Architect's Supplemental Instructions

PROJECT: *(name and address)*
Wilma P. Mankiller Health Center
Expansion
Stilwell, OK

ASI INFORMATION:
ASI Number: Bid Package 01 - ASI 004

Bid Package 01- ASI 04 – Wilma P. Mankiller Health Center Expansion

A1 FOUNDATION PLAN - SECTOR 2
SCALE: 1/8" = 1'-0"

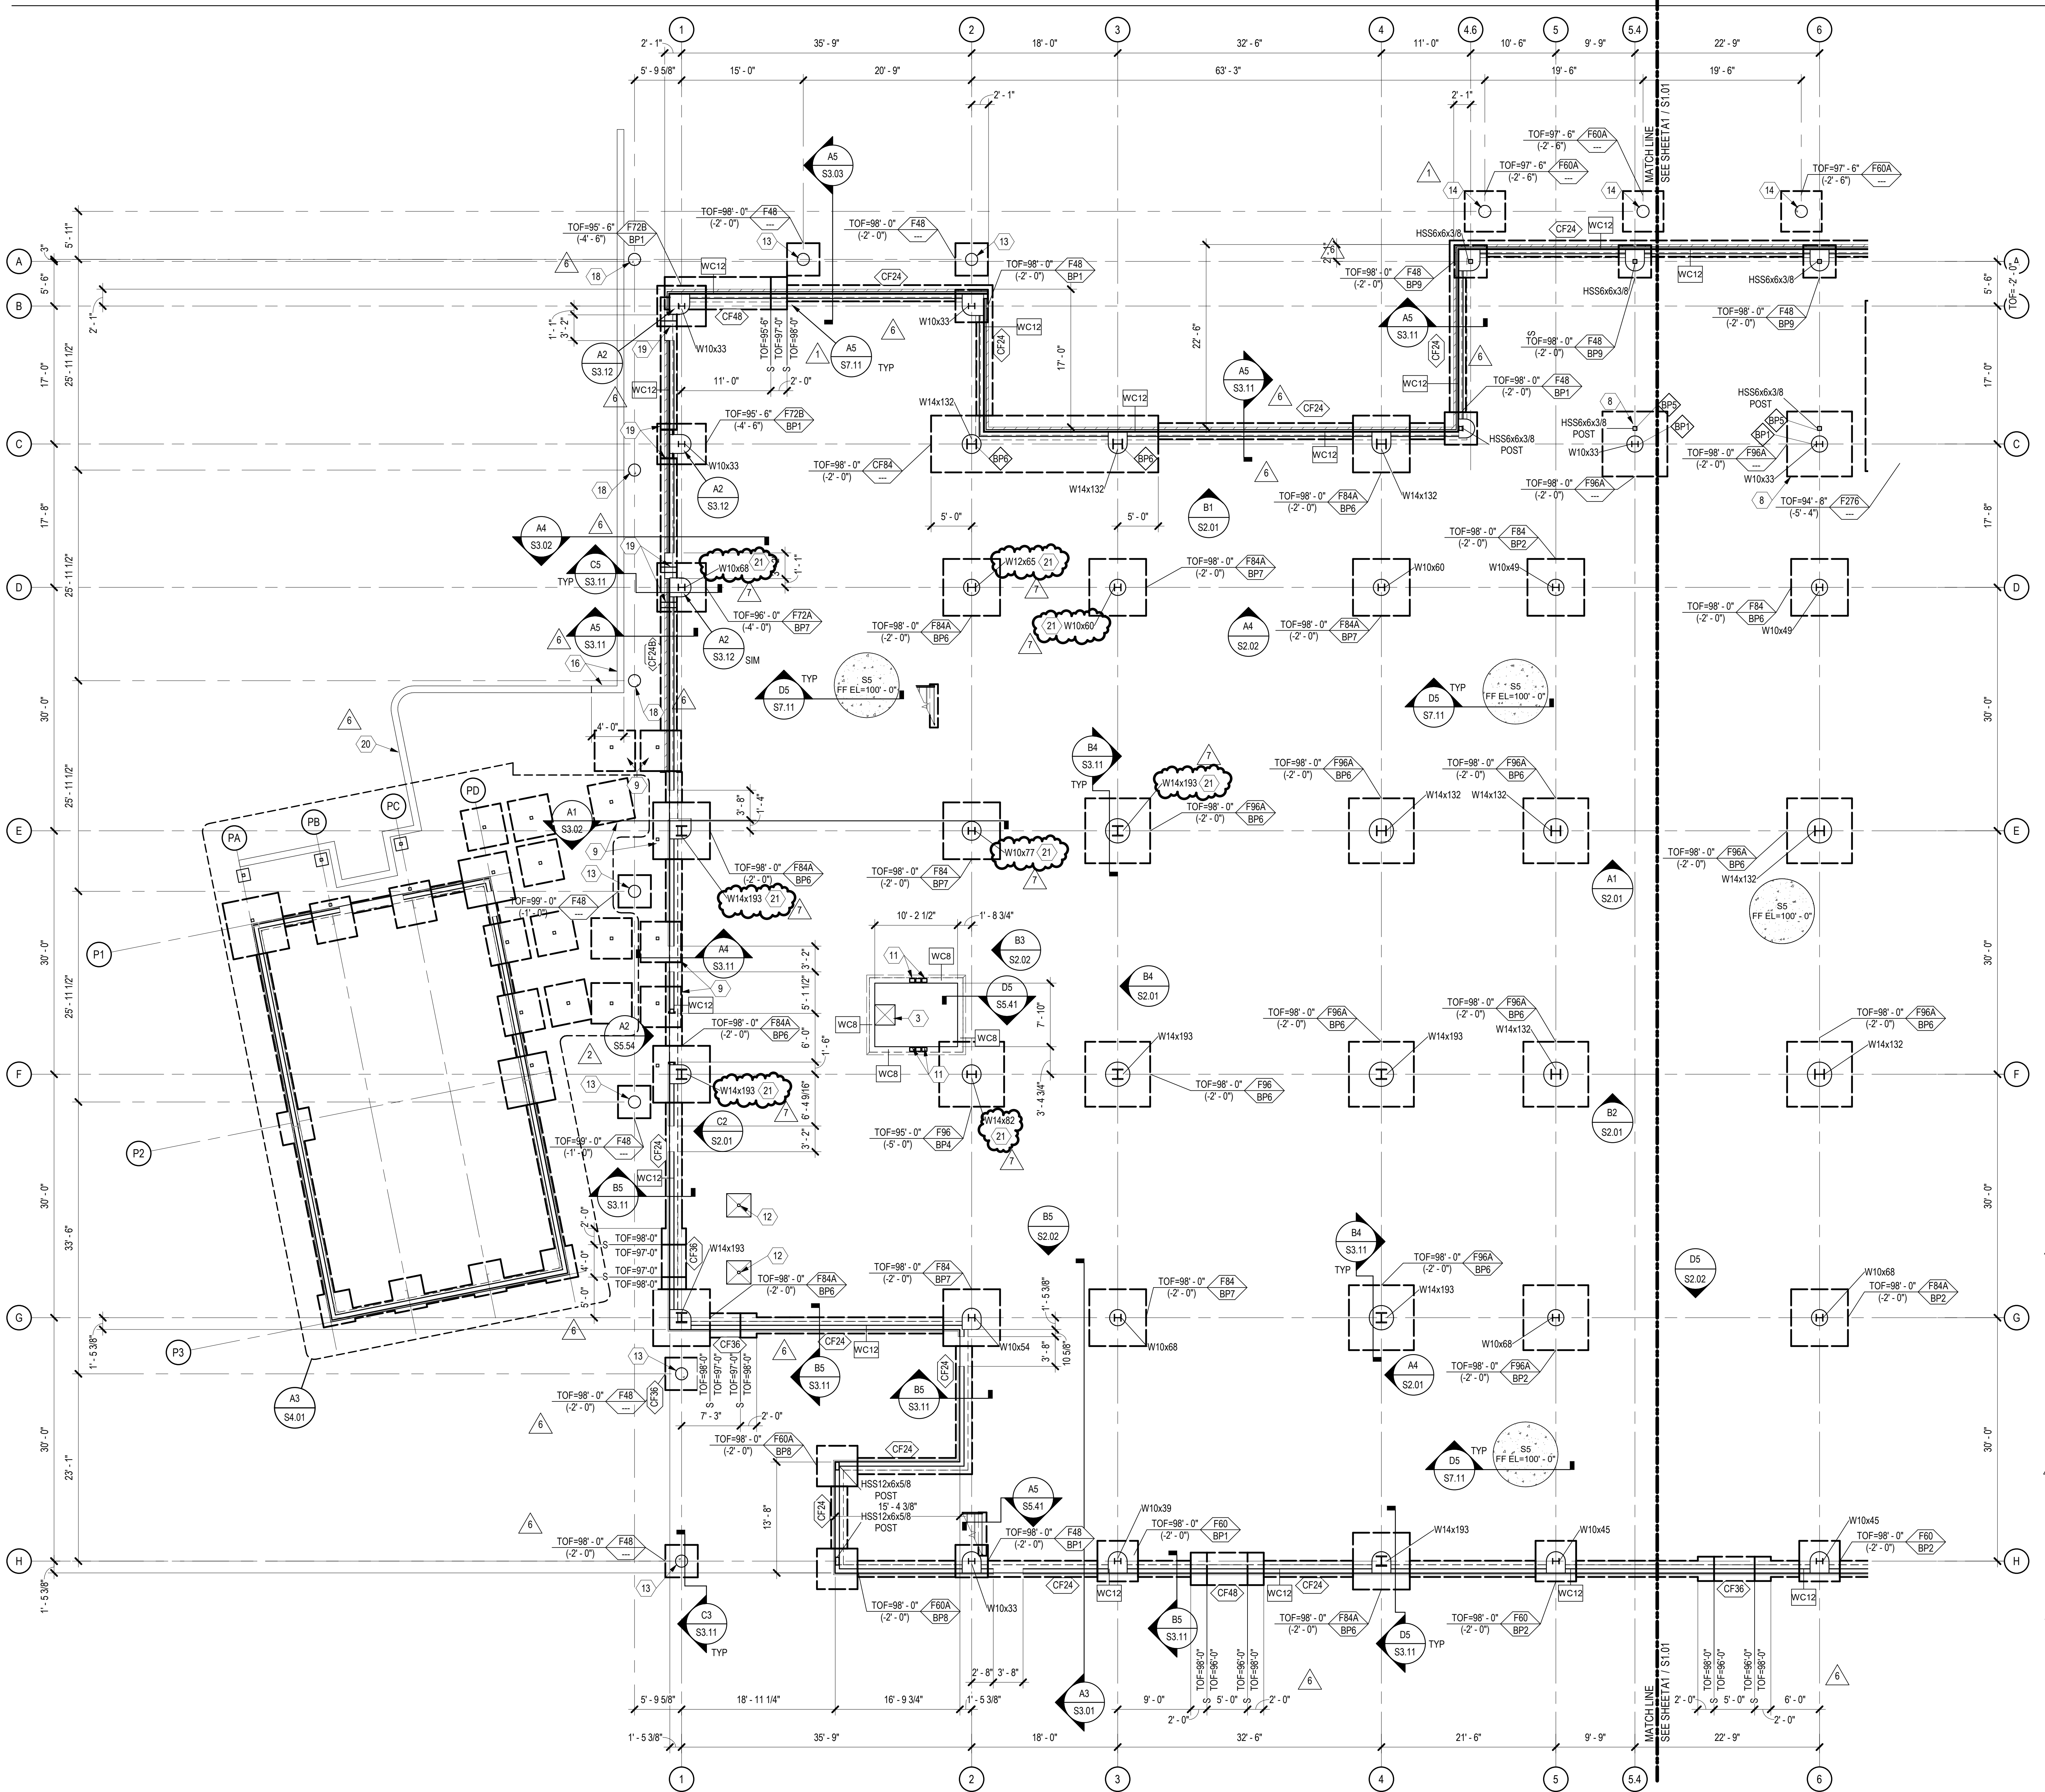
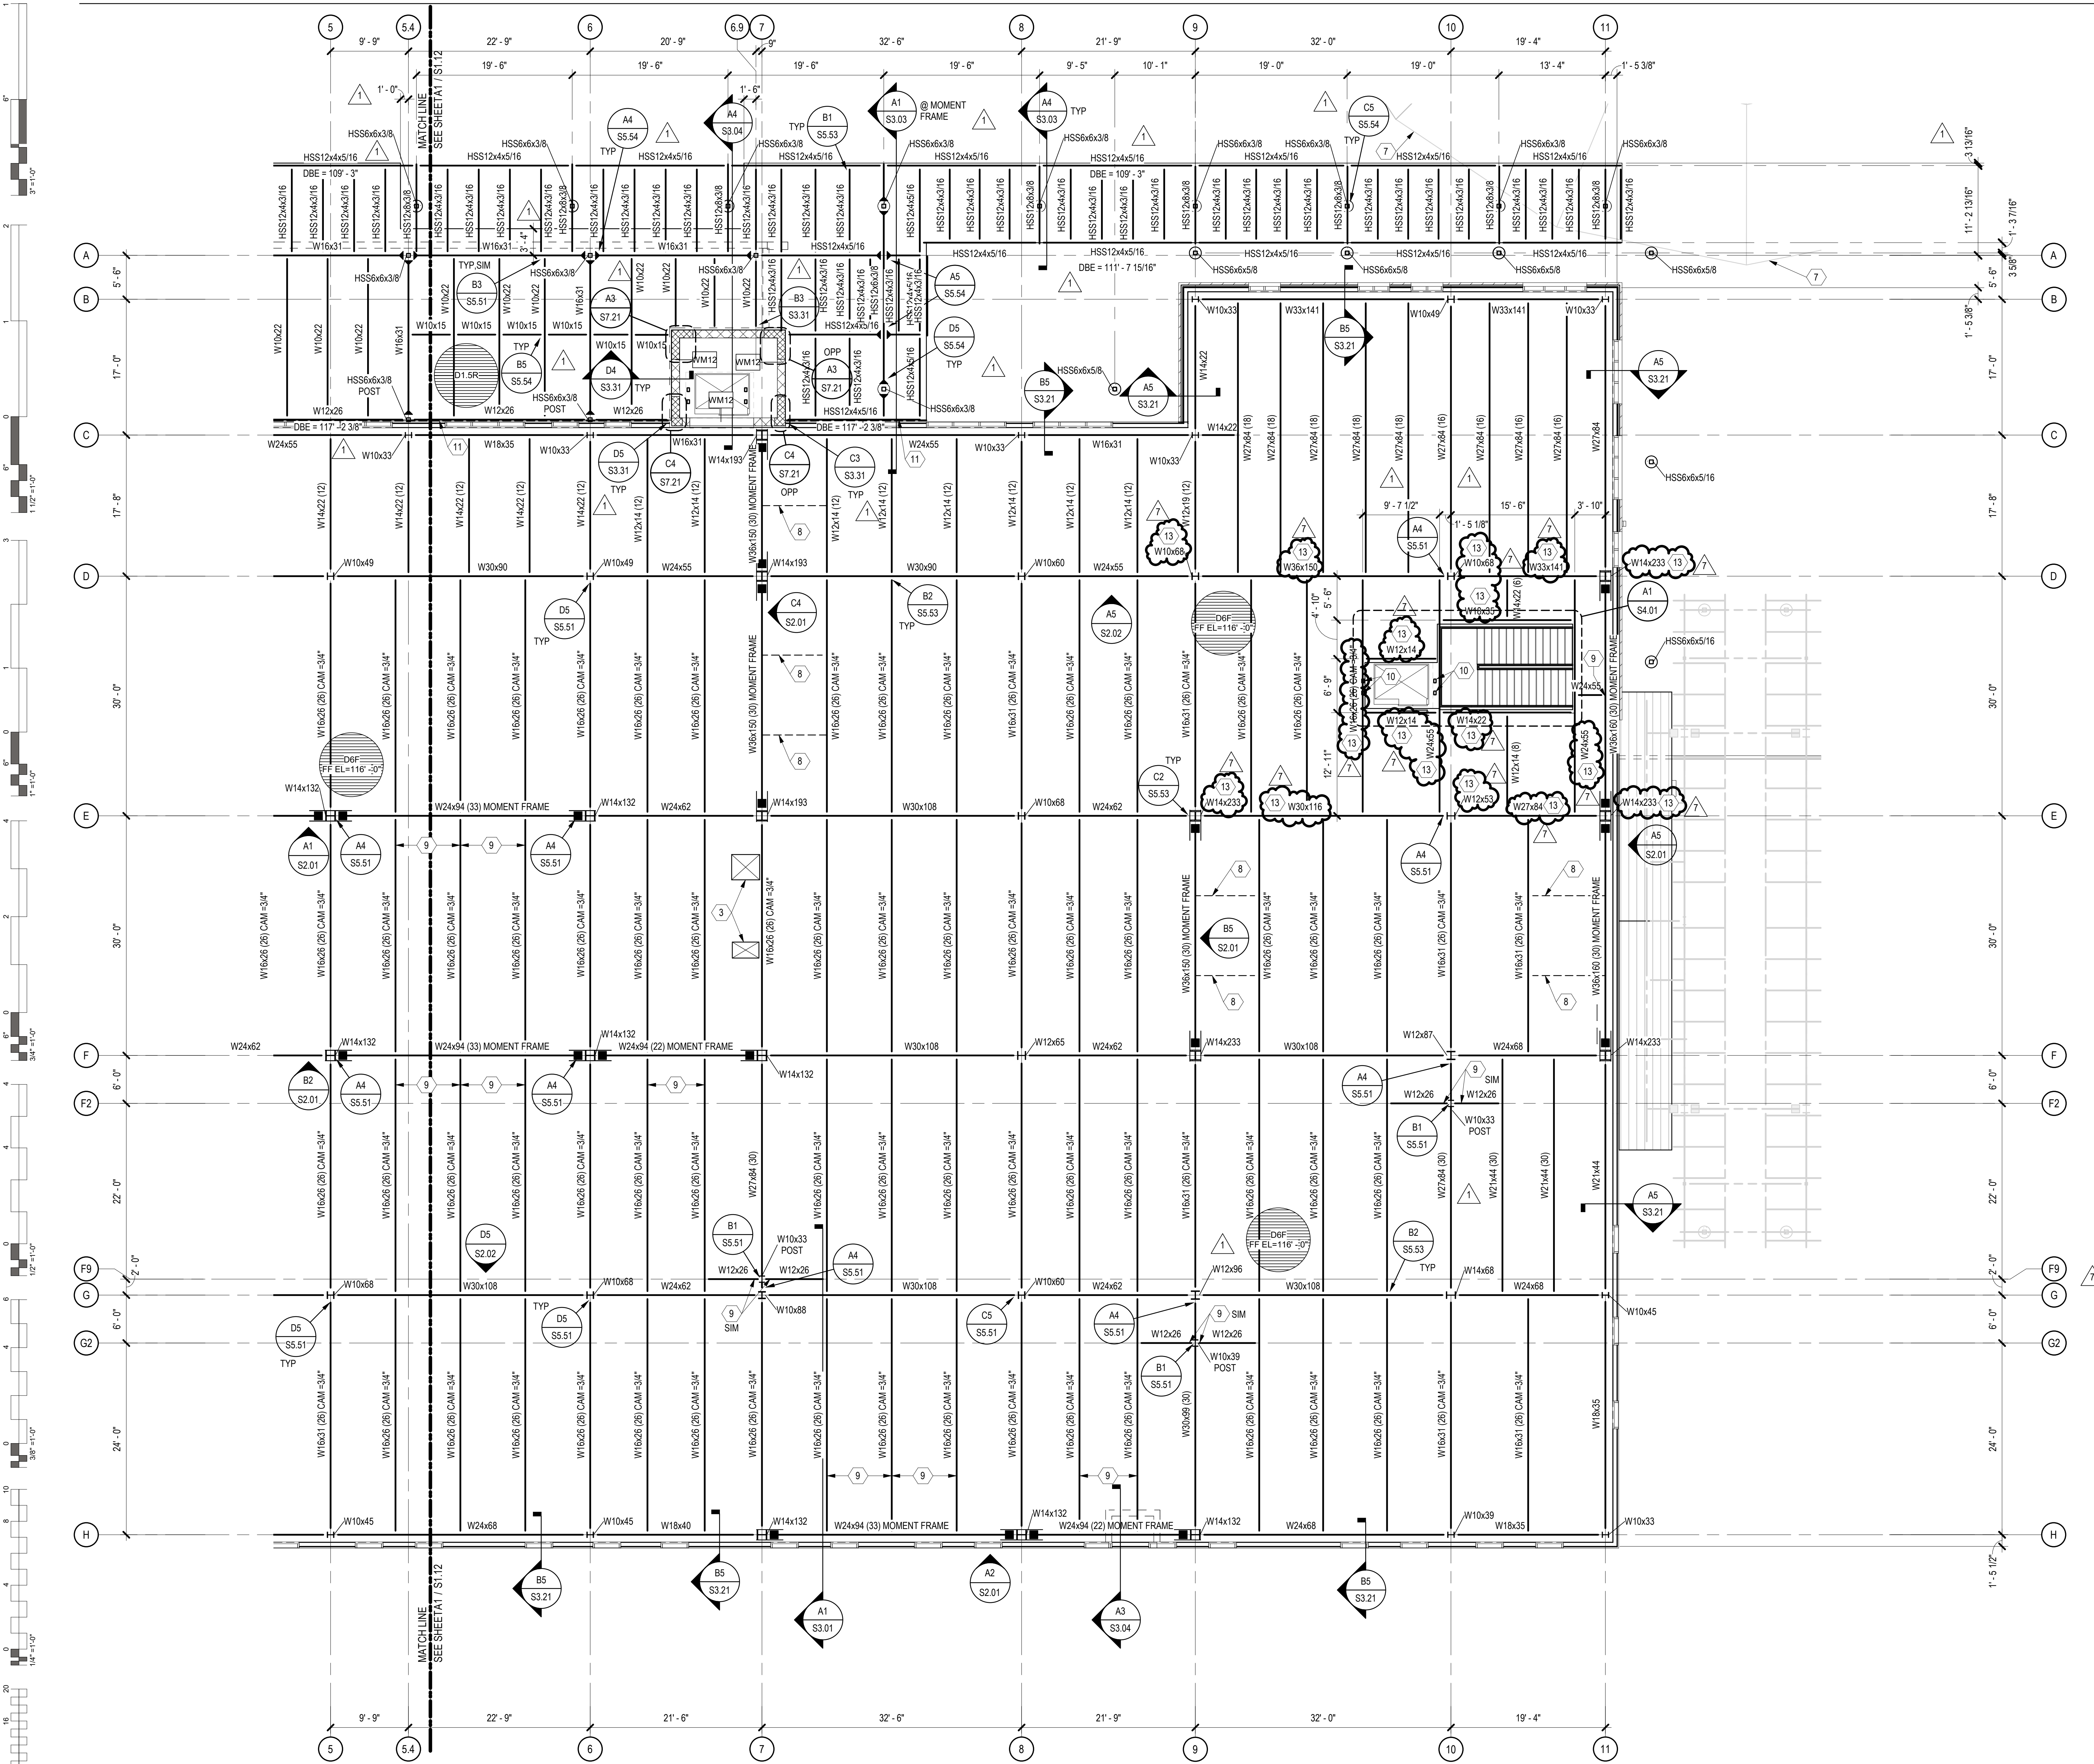
<u>Sheet</u>	<u>Description</u>
S1.01	Keynote 21, with associated plan annotations, added.
S1.02	Keynote 21, with associated plan annotations, added.
S1.11	Keynote 13, with associated plan annotations, added.
S1.12	Keynote 13, with associated plan annotations, added.
S1.13	Keynote 13, with associated plan annotations, added.
S1.21	Keynote 9, with associated plan annotations, added.
S1.22	Keynote 9, with associated plan annotations, added.

- SEE C3 / S3.12 FOR SUPPORT OF CONTINUOUS FOOTING.
- SITE RETAINING WALL. SEE B2 / S3.12 SEE CIVIL DRAWINGS FOR EXTENT.
- STRUCTURAL MEMBER, INCLUDING ASSOCIATED DECK EDGE SUPPORT PER S7.21, SUPPORTING EXIT STAIRS AND/OR RATED ENCLOSURE. SEE LIFE SAFETY DRAWINGS FOR FIREPROOFING REQUIREMENTS.
